Document ID 1334122	Version 1.0	Status Approved	Reg no	Page 1 (7)
Author Allan Hedin			Date 2012-02-13	
Reviewed by Olle Olsson			Reviewed date 2012-02-15	
Approved by Helene Åhsberg			Approved date 2012-02-16

SKB's response to additional question from the NEA IRT

In an e-mail forwarded from SSM, dated 3 February 2012, the NEA IRT has put the following, final question to SKB as part of the on-going review of the safety assessment SR-Site:

Figure 2. Summary of far-field mean annual effective dose for probabilistic calculations for the corrosion scenario. The peak doses are given in parentheses in µSv.

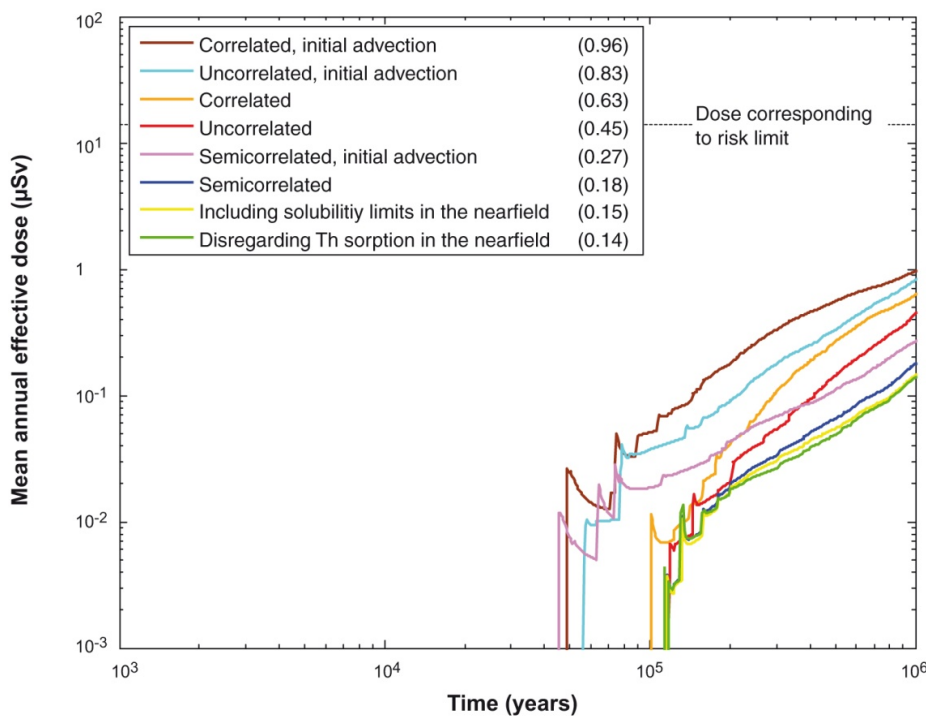
A number of cases of consequence calculations for the corrosion scenario are shown in Figure 13-40 of the SR-Site main report, reproduced as Figure 2 below.

As seen in the figure, the semi-correlated base case (the dark blue curve) yields a dose that is less than an order of magnitude below the pessimistic compliance case, i.e. the correlated case with initial advection (the brown curve). Assumptions underlying the transport cases are discussed in the following.

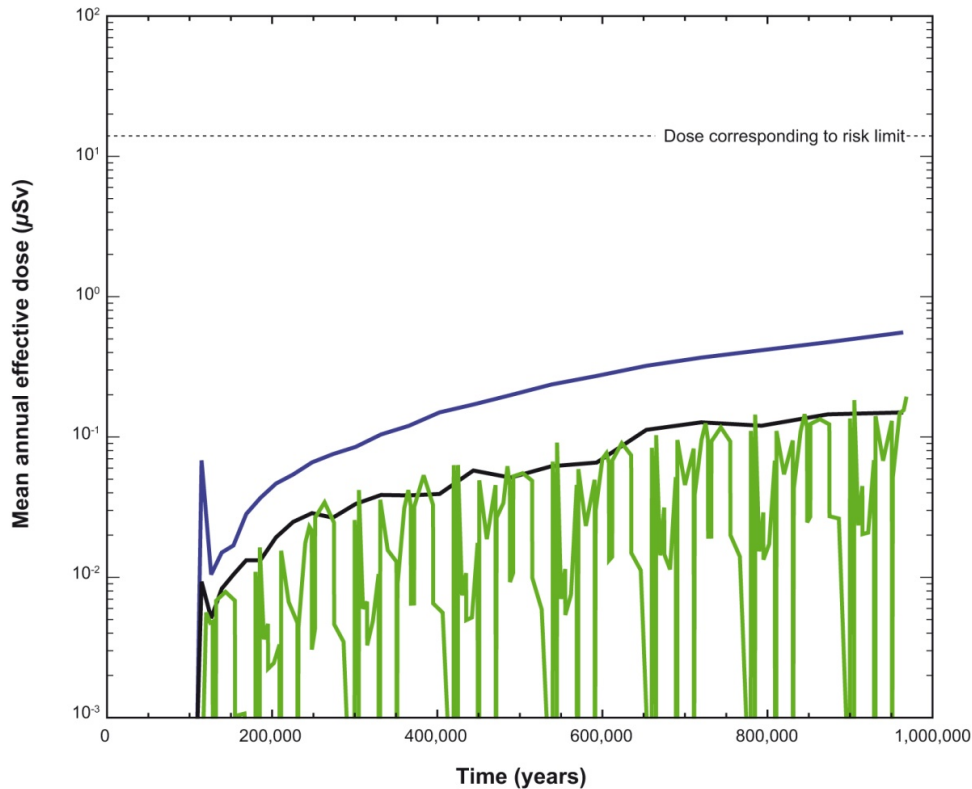
- All dose curves shown in Figure 2 above are calculated under the assumption that present day, temperate conditions prevail throughout the one million year assessment period. The effect on system behaviour of a varying climate is illustrated in Figure 3 (identical to Figures 13-33 in section 13.5.6 of the SR-Site main report). The result demonstrates that the consequences for temperate conditions essentially form an upper bounding envelope of the more rapidly varying results of a time dependent climate.
